Service Bulletin

S.B. No: 133

Title: INSPECTION OF FLAP LEVER PIVOT ATTACHING POINT FOR CRACKING

FIGURE 1 FLAP OPERATING HANDLE
(ITEMS DELETED FOR CLARITY)

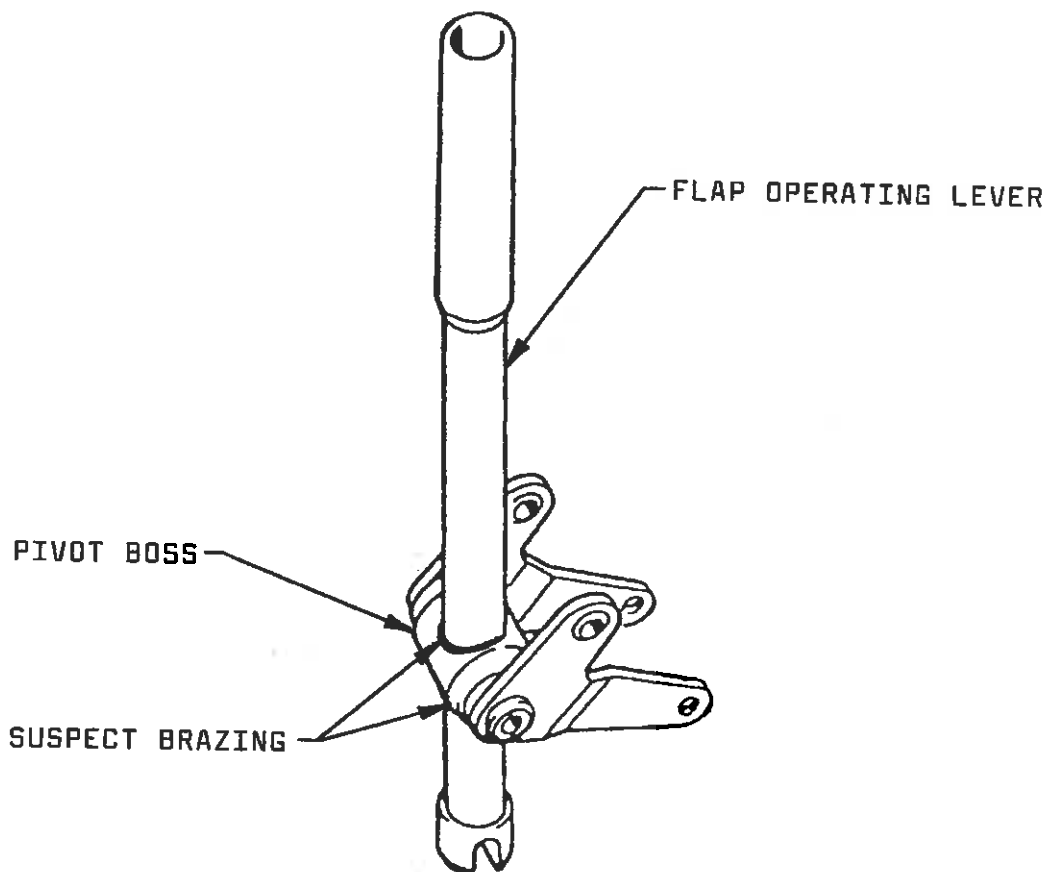
Cases have been reported of cracking in the brazed joints above and below the Flap Operating Lever pivot point. This SB requires an inspection to be carried out on the Flap Lever, pivot boss.

3. Inspect, using a strong light and mirror, all brazing between lever and pivot boss, above and below pivot, refer Figure 1.
 - i. If no cracking is present in the brazed joint, then certify item as serviceable. Annotate aircraft Logbook "Service Bulletin 133 complied with". Re-inspect at next Annual until welded lever Part number T67B-45-262 at issue 2 and subsequent incorporated.

- ii. If brazed joint is found to be cracked, remove flap lever assembly, strip down flap lever completely and replace lever with welded lever Part number T67B-45-262 at issue 2 and subsequent, and annotate Logbook "SB 133 complied with".
